ERA Decision and Explanatory Memorandum on the Draft Technical Rules dated 11 April 2006 for Western Power's South West Interconnected Network

Western Power Response to the ERA Decision and Explanatory Memorandum on the Draft Technical Rules dated 11 April 2006 for Western Power's South West Interconnected Network

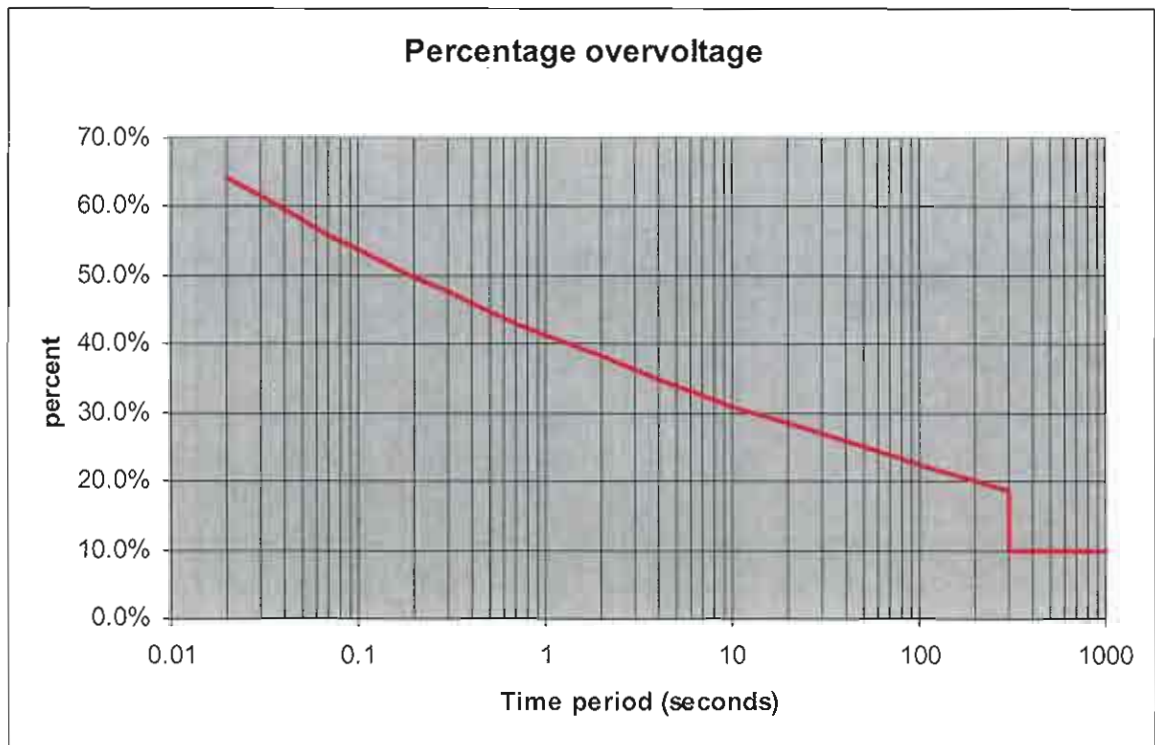
3.5.2 (d) (4)	<p>Change reference 3.3.4.10 to 3.5.1 (d)</p>	<p>Editorial</p>
3.5.4 new clause	<p>Put back clause 3.5.4 titled <u>"Protection Design Philosophy Document"</u> and worded as follows: <u>"Unless otherwise</u></p>	<p>Clause 3.5.4 has been deleted in this document, however it is our understanding that it was agreed to modify it slightly, and include a new attachment. We therefore suggest to re-insert modified Clause 3.5.4 and</p>

<p><u>agreed by the Network Service Provider, a User must provide the Network Service Provider with sufficient details of the proposed protection designs, together with all relevant equipment parameters for the Network Service Provider's review. Refer to Attachment 11 for specific document submittal requirements. The timeline for provision of these documents is to be detailed in the access contract."</u></p>	Attachment 11 (provided separately).
Attachment 11, new 3.5.5 new clause	<p>Add Attachment 11 (provided separately)</p> <p>Put back Clause 3.5.5 titled: "<u>Protection Settings Philosophy Document</u>" and worded as follows:</p> <p><u>"Unless agreed otherwise, Users must provide the Network Service Provider with full details of proposed protection settings on all equipment that may have an impact on the transmission system or the distribution system. Refer to Attachment 12 for specific document submittal requirements. The timeline for provision of these documents is to be detailed in the access contract."</u></p>	<p>Follow up of our previous comment on Clause 3.5.4.</p> <p>Clause 3.5.4 has been deleted in this document, however it is our understanding that it was agreed to modify it slightly, and include a new attachment. We therefore suggest to re-insert modified Clause 3.5.5 and Attachment 12 (provided separately).</p>
